Preliminary Design Report

Wastewater Treatment Facility Upgrade

Project No.: 20828B – Newport, NH Preliminary Design Submittal

Subject: Response to Comments – Preliminary Design Report (30%)

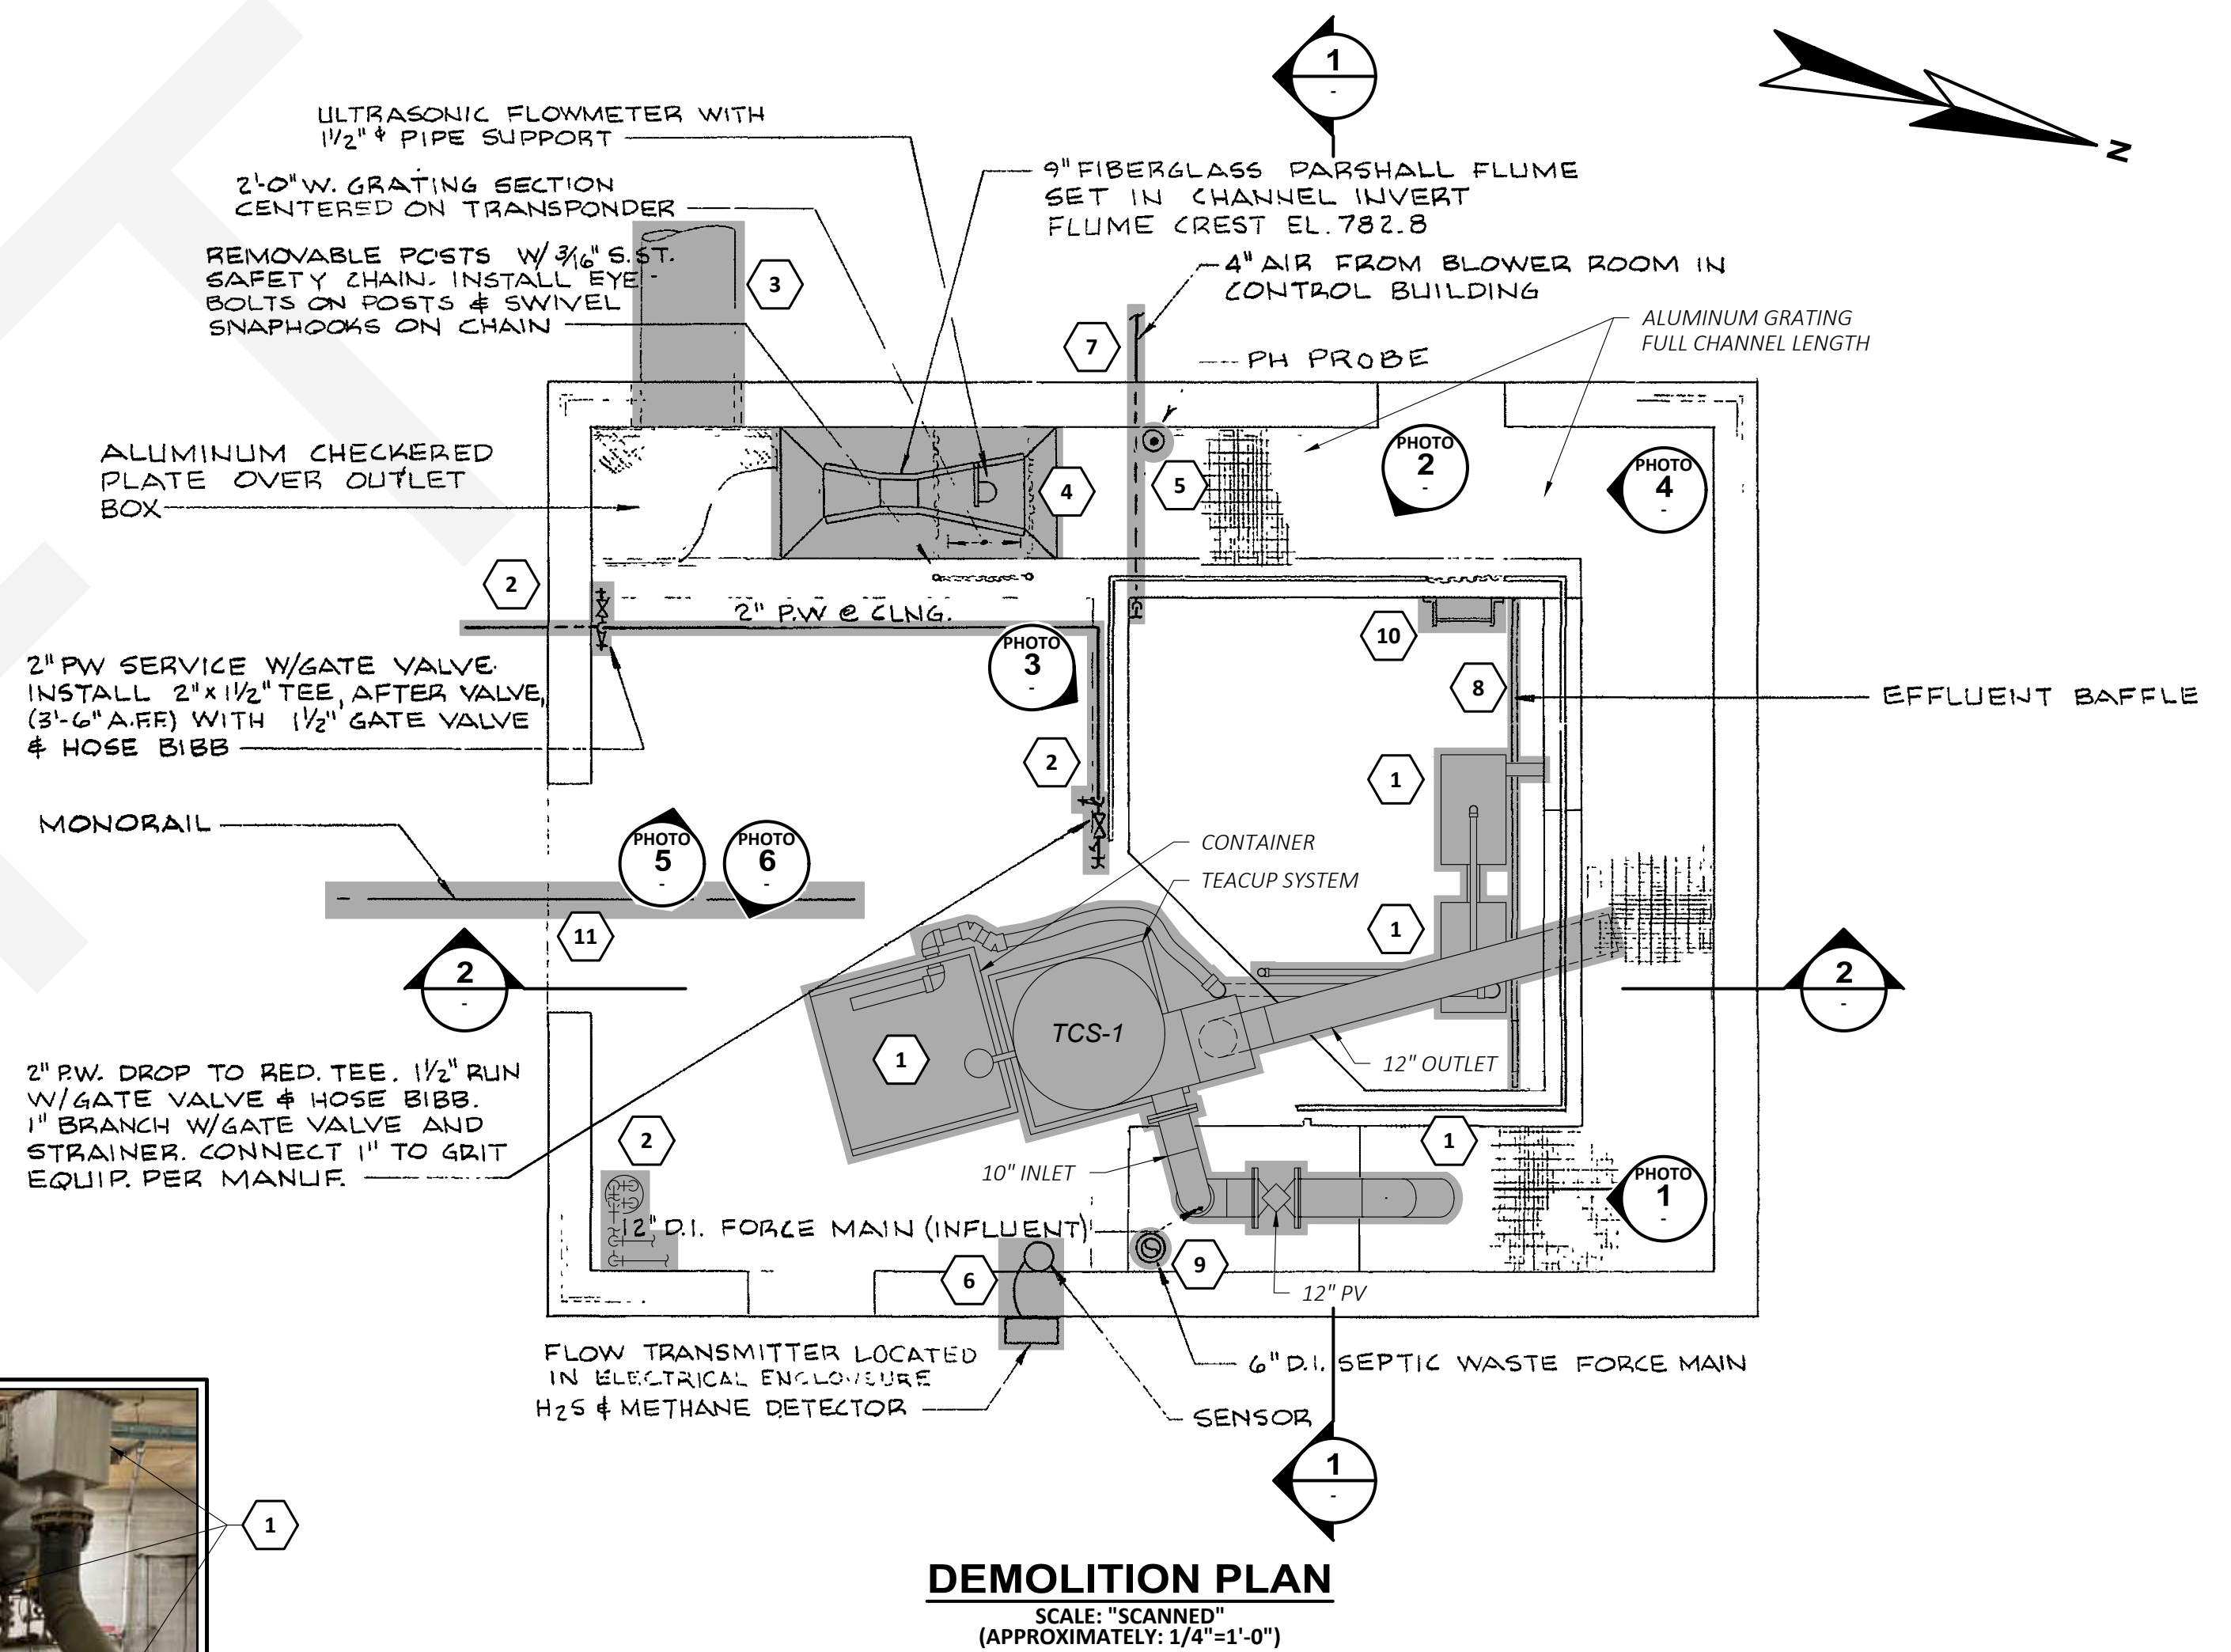
37. Hydraulic Profile (PR-9) Add lagoons and flow path for Q > 1.5 mgd. ***A hydraulic profile for the influent equalization flow path will be provided with the next submittal (60%) once the piping and plan for existing structures is finalized.***
38. Influent PS (PR-16) Is Isolation gate provided between wet well? ***The influent pump station wet wells include an existing isolation gates.***
